INFORMATION CIRCULAR

N. 012020

Subject : Updating of the installation instruction of ALA PELLET AETERNUM

How does the label change ?

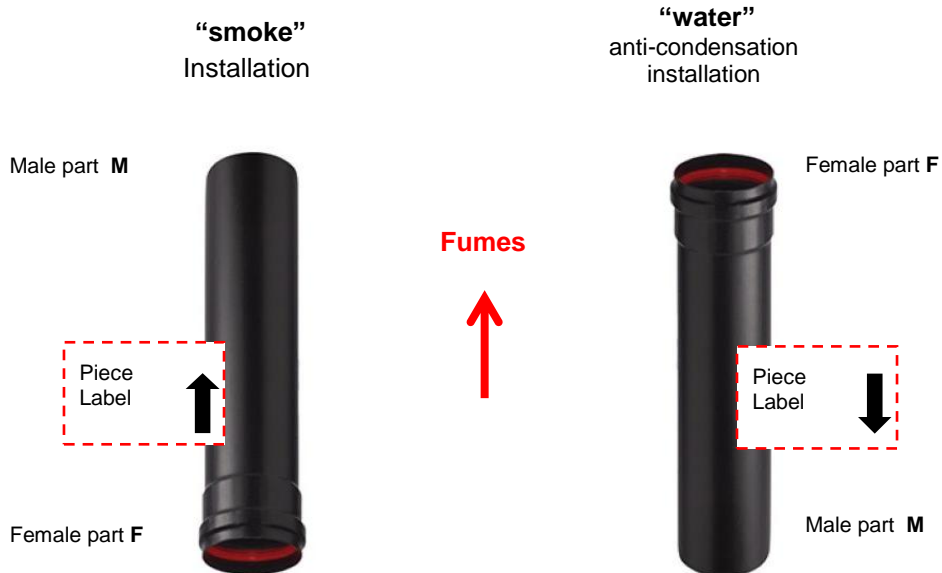
- With the use of Viton seals, the pipes must be installed with the **"water" anti-condensation installation**, that is, with the male coupling at the bottom and the female part at the top.
- The same anti-condensation installation is recommended even with traditional silicone gaskets (by rotating the tube even if the label is "smoke" applied), alternatively carry out assembly by regularly following the smoke arrow (**"smoke" installation**).

The label does not change and remains applied by default for **"smoke" installation**, that is, with the smoke arrow from the female to the male coupling.
